1.03 **NARRATIVE OF REVISIONS** for attached drawings labeled as Delta # 1 Dated 08.21.2026 on the drawings and labeled as ADDENDUM 1 on the specifications per DSA requirements.

B26.014 CUYAMACA COLLEGE AUTO LIFTS RTEPLACEMENT

BUILDING K AUTO LIFTS REPLACEMENT PROJECT: 2026-07-15 DSA APPROVAL SET

BUILDING K
NEW AND DEMO FLOOR
PLAN

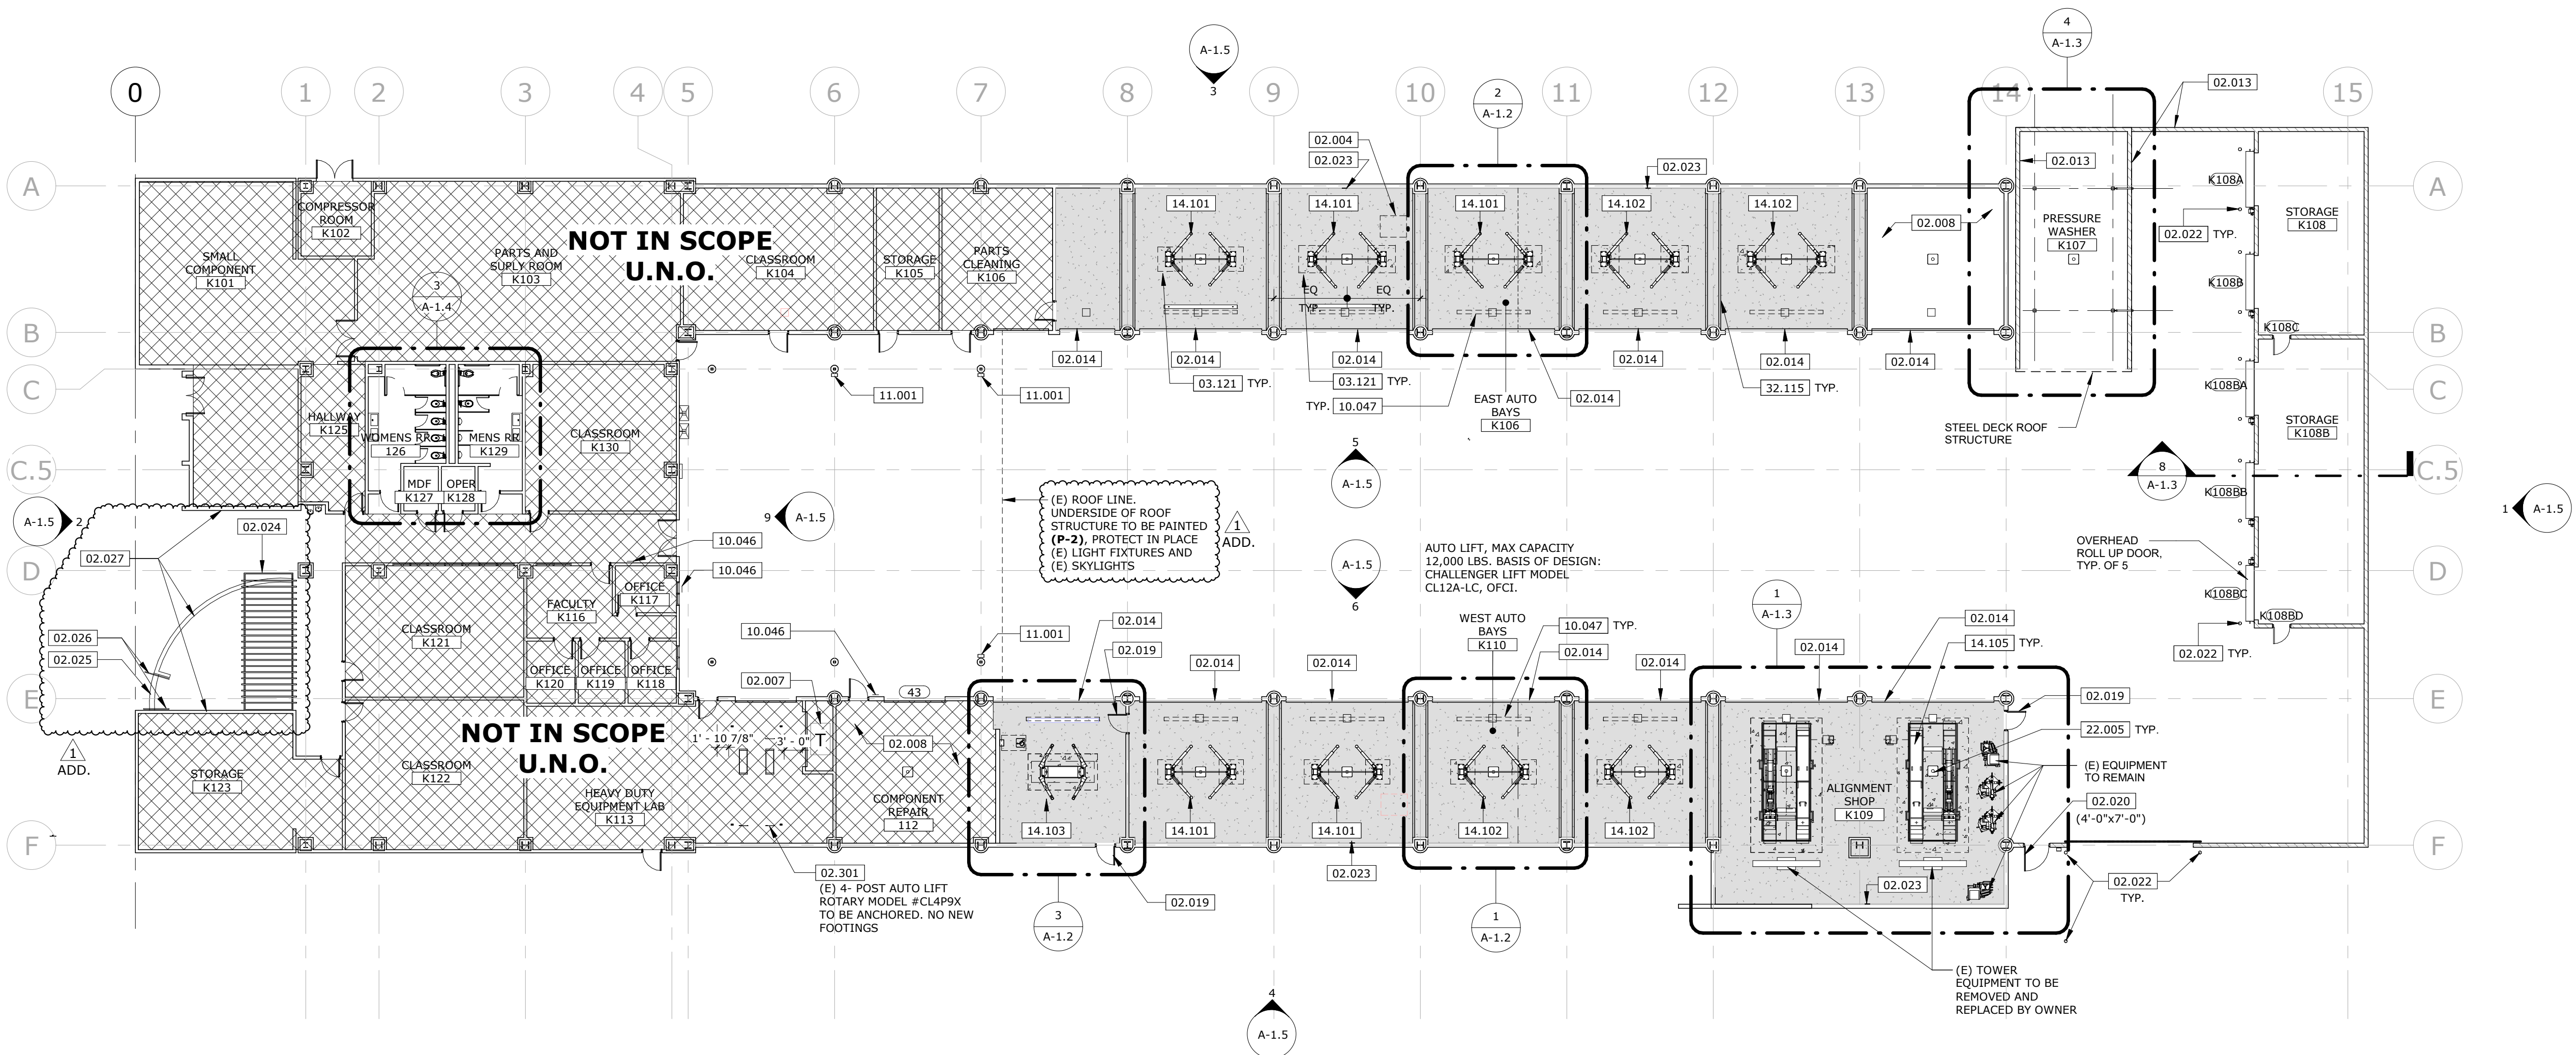
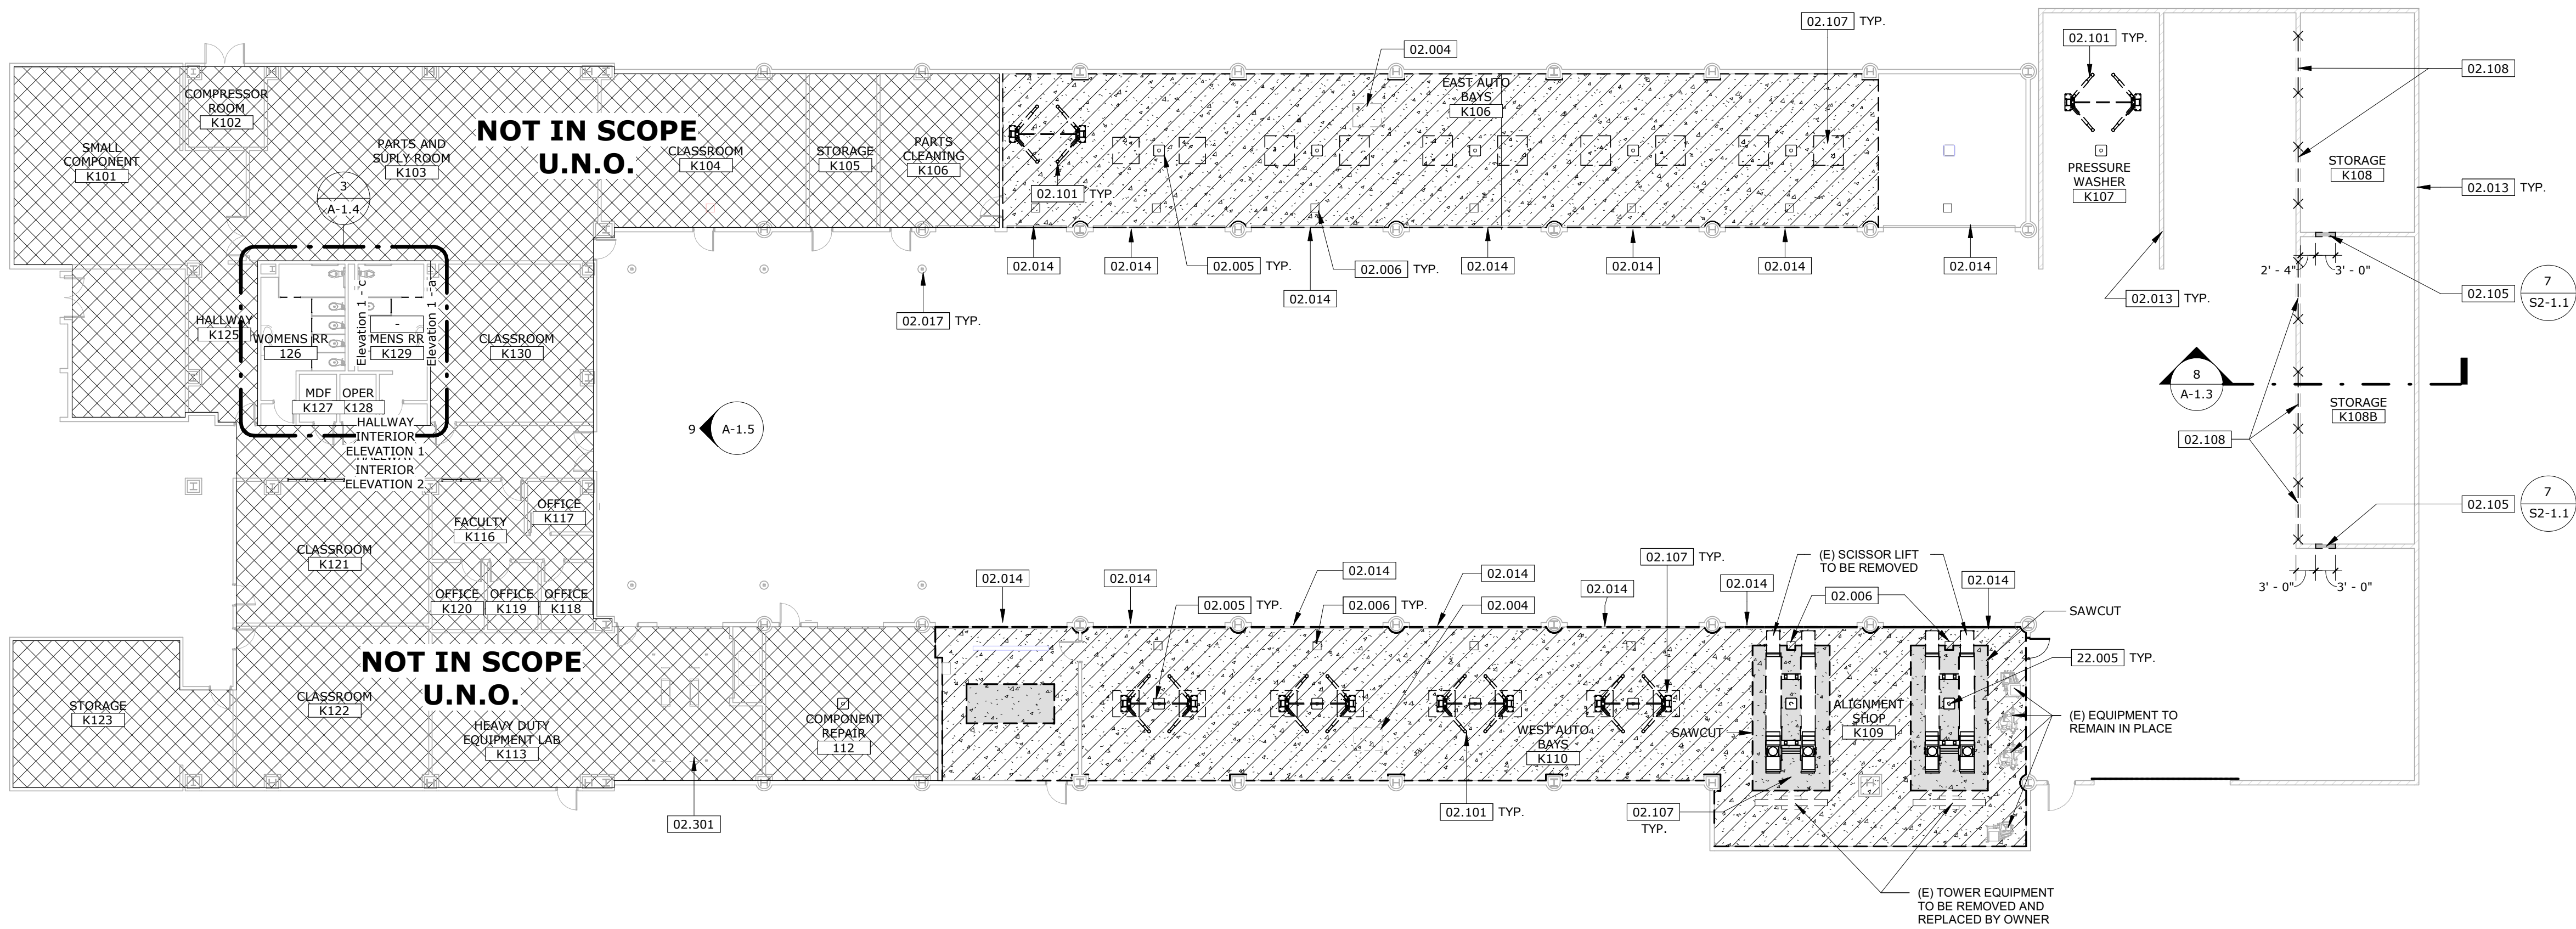
Item No. 1.2 Reference Sheet A-1.1 – NEW AND DEMO FLOOR PLAN

1.2.1 Revise sheet A-1.1 per clouded areas listed below:

(a) Revise detail 1 with added note and keynotes.

CL10 TYPICAL SECTION

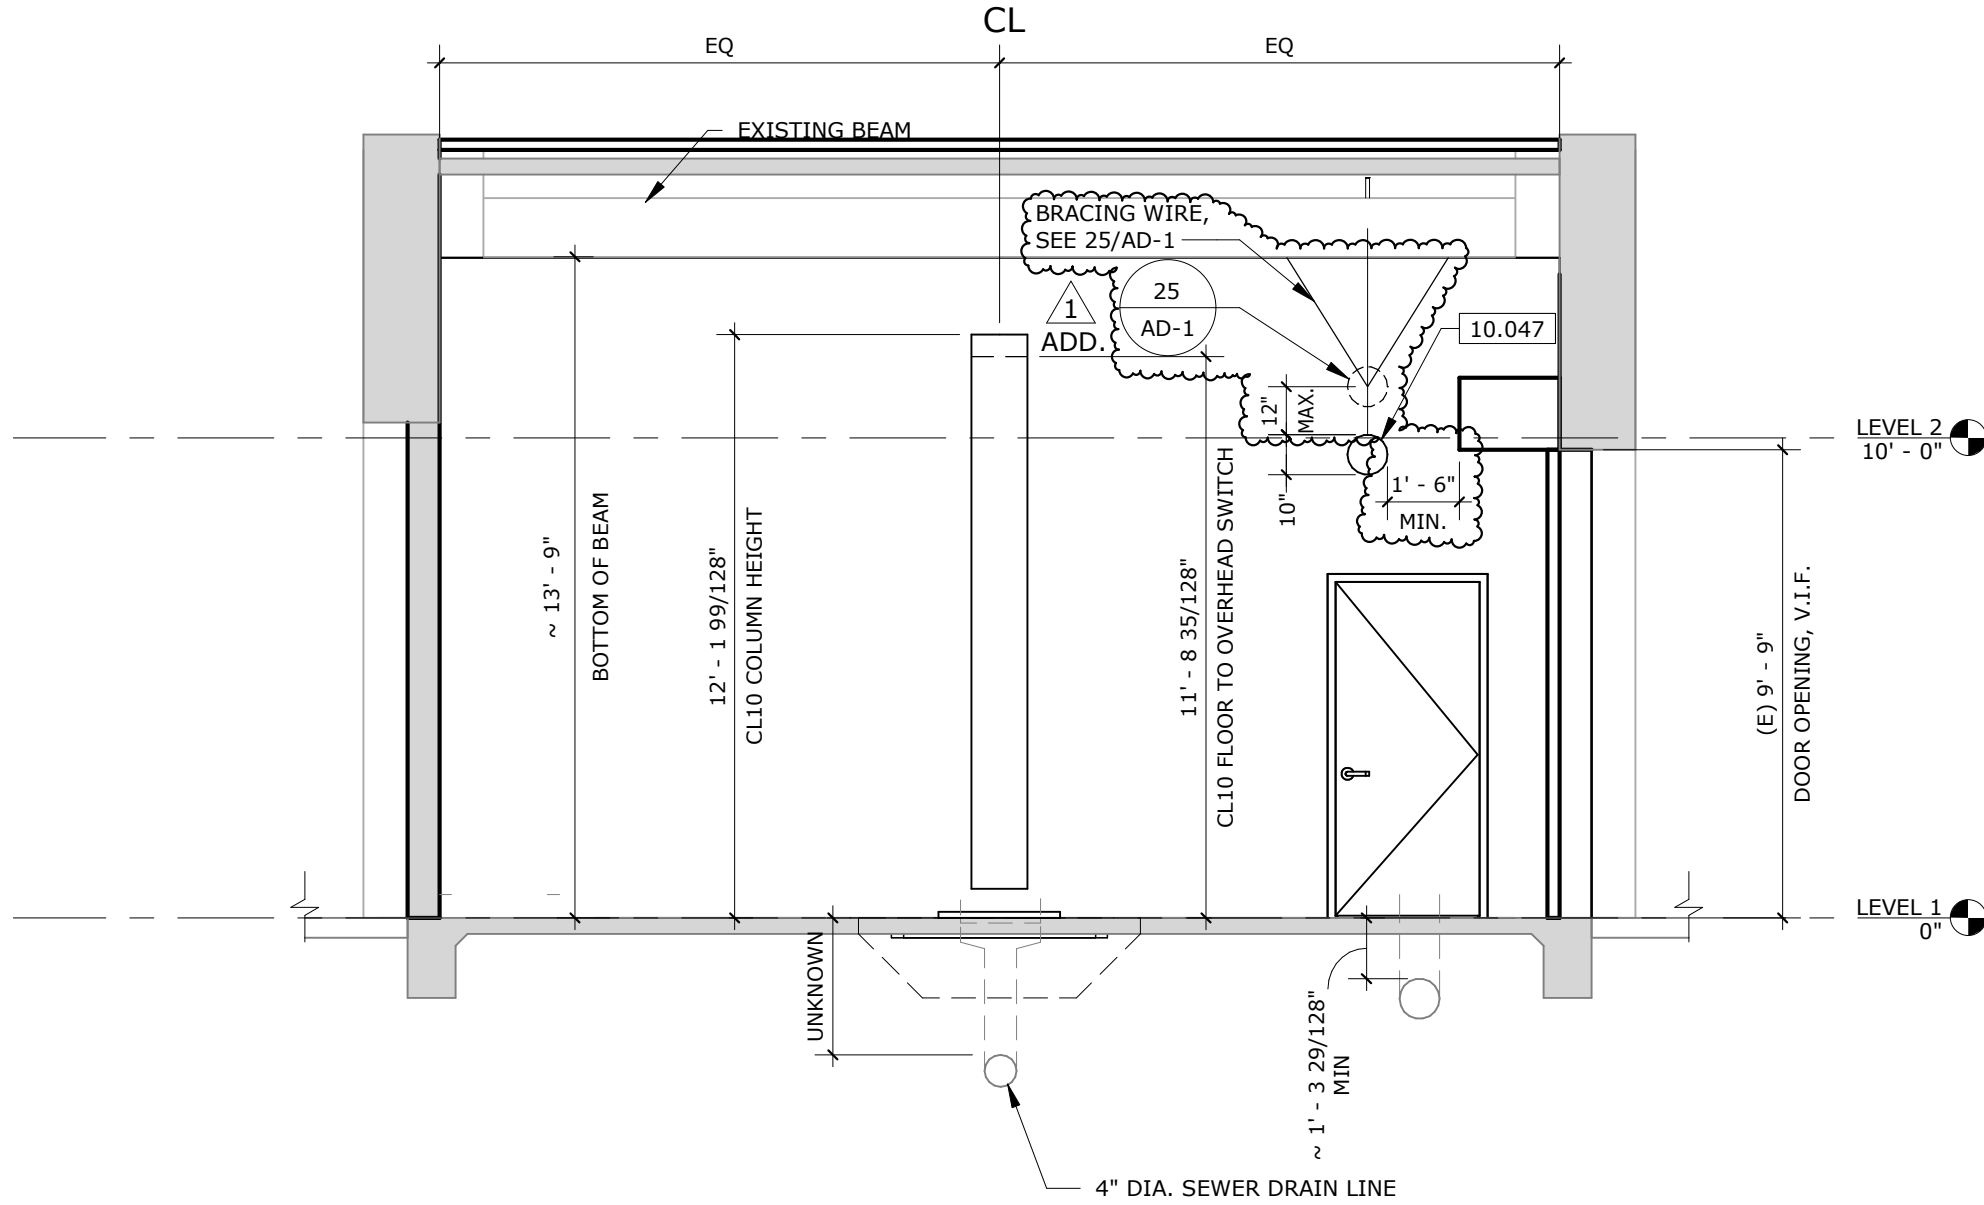
(b) Revise details 1, 2, 3, 4 & 5.

FLOOR PLAN SOUTH - LIGHTING, POWER & COMM.

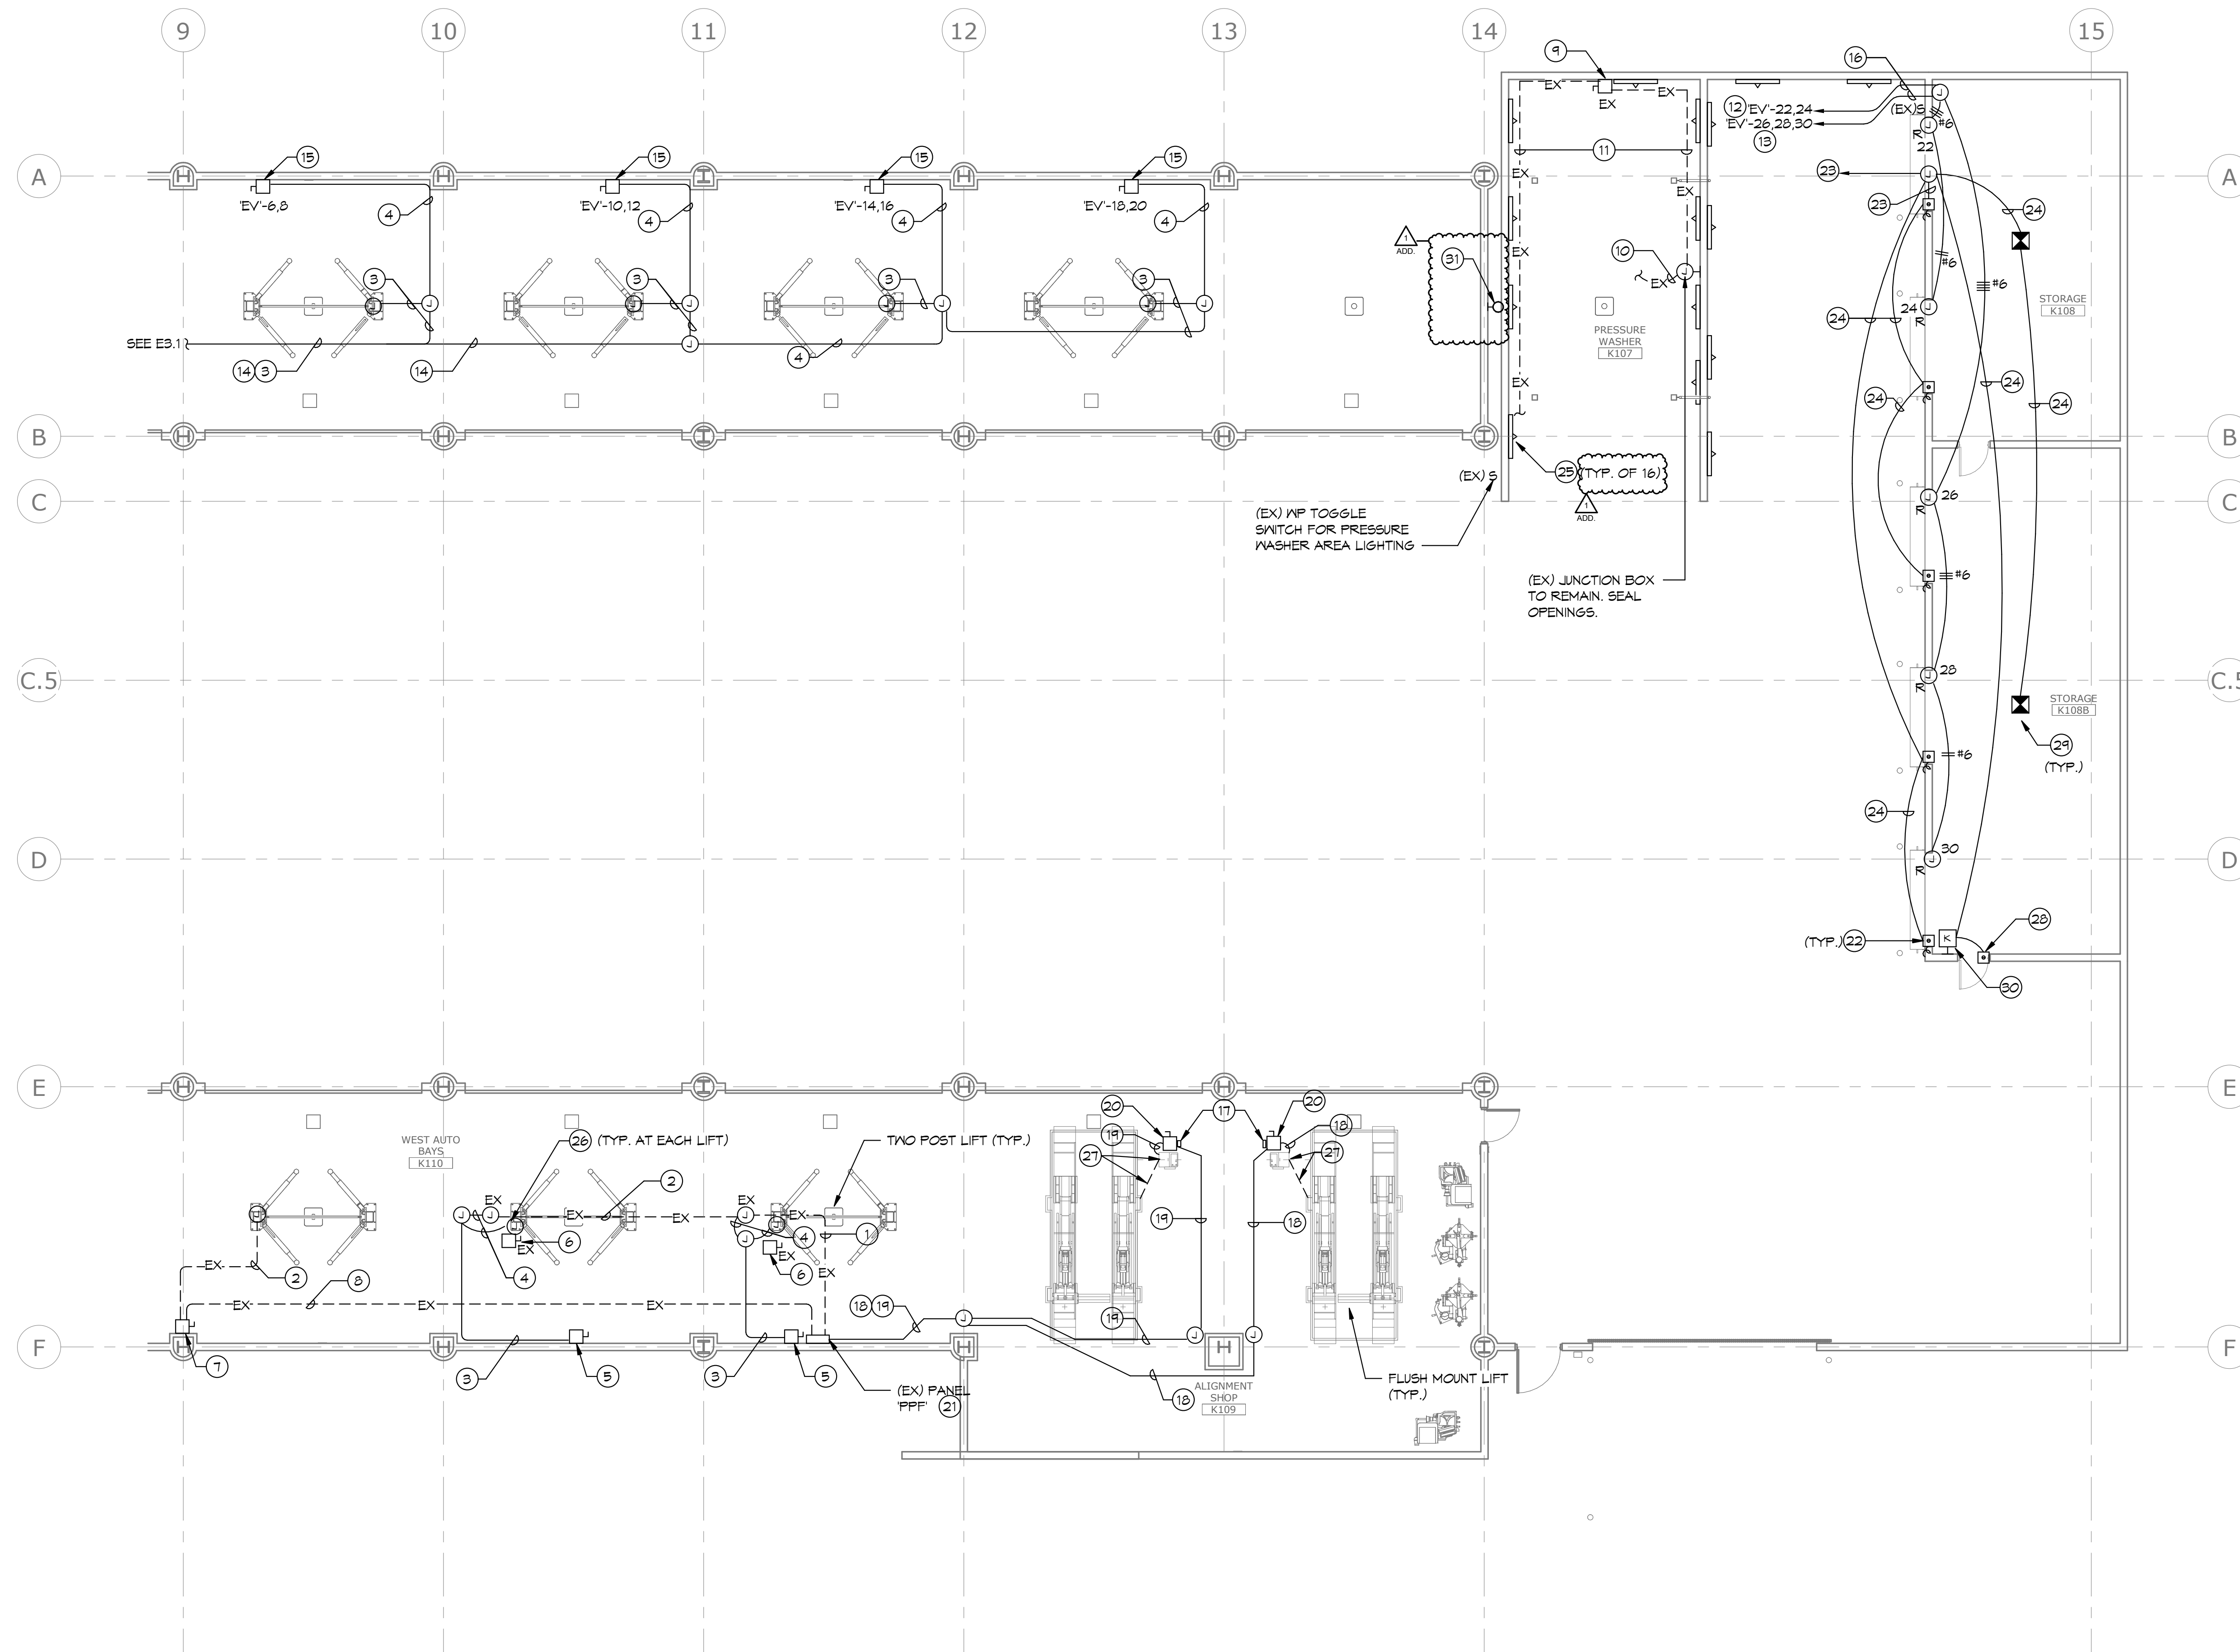
Item No. 1.7 Reference Sheet E3.2 – FLOOR PLAN SOUTH – LIGHTING, POWER & COMM.

- 1.7.1 Revise Sheet per clouded areas below:
(a) Revised floor plan.
(b) Revised Keynote #25.
(c) Added keynote #31.

31) EXISTING LED WALL PACK SHALL BE REMOVED AND RETURNED TO THE DISTRICT. MAINTAIN CONTINUITY OF EXISTING LIGHTING CIRCUIT AND CONTROL. EXISTING CABLING SHALL BE SPLICED IN EXISTING BACKBOX. IF BACKBOX DOES NOT EXIST, PROVIDE NEW BOX ON INTERIOR WALL AND INTERCEPT CONDUIT AND CABLING AS REQUIRED. PROVIDE STAINLESS STEEL BLANK PLATE AND SEAL OPENINGS AS REQUIRED. PAINT BLANK PLATE TO MATCH WALL FINISH.
